**AMENDMENTS TO THE DRAWINGS**

### **REMARKS**

Application No.: 10/754,565  
Amendment dated September 29, 2005  
Reply to Office action dated June 29, 2005

Docket No.: M4065.0997/P997

**FIG. 1**

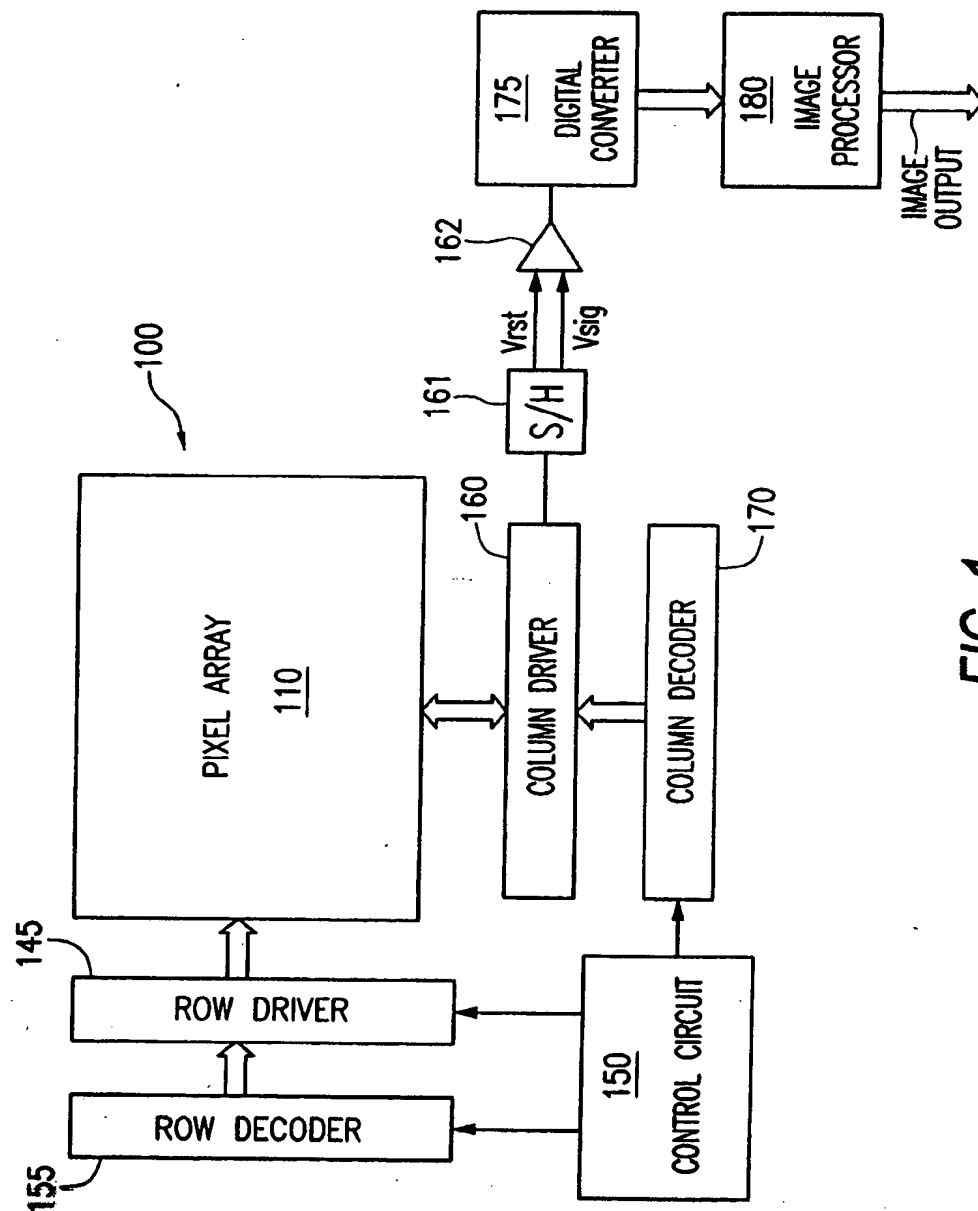
Figures 1 and 2 stand objected to as failing to comply with 37 CFR 1.84(p)(4) and (5). Figures 1 and 2 have been revised to indicate that they are prior art and Figure 2 has been revised to re-label the row select transistor with reference character "36." Applicant submits that the figures are in compliance with 37 CFR 1.84. In light of this revision, Applicant respectfully requests that the objection to the figures be withdrawn.

(PRIOR ART)
